Historic Landmarks and Preservation Districts Commission

Report to the Committee

15COA1187

Property Address: 174 William Street

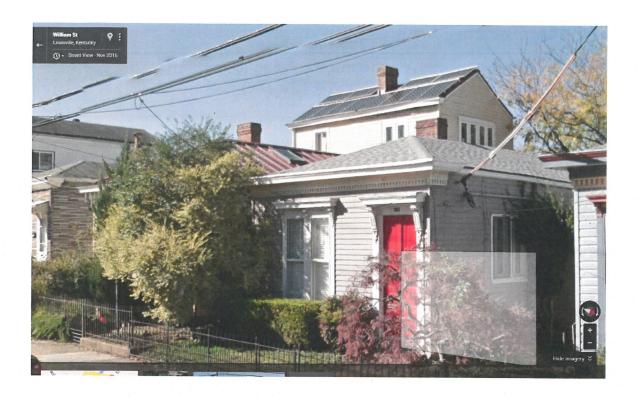
| | Guideline | Finding | Comment |
|-----|--|---------|--|
| R17 | Antennae, satellite dishes, skylights, vents, roof-top mechanical units, decks, terraces, dormers, or high-profile solar panels should not be installed where they can be seen from a building's street address façade or primary elevation. Skylights should be flush (not the "bubble" type) with curbs painted to match the color of the roof material. Consolidate antennae wherever possible. | - | Skylight meets the design guidelines. Solar panel installation faces the building's street address façade or primary elevation. |
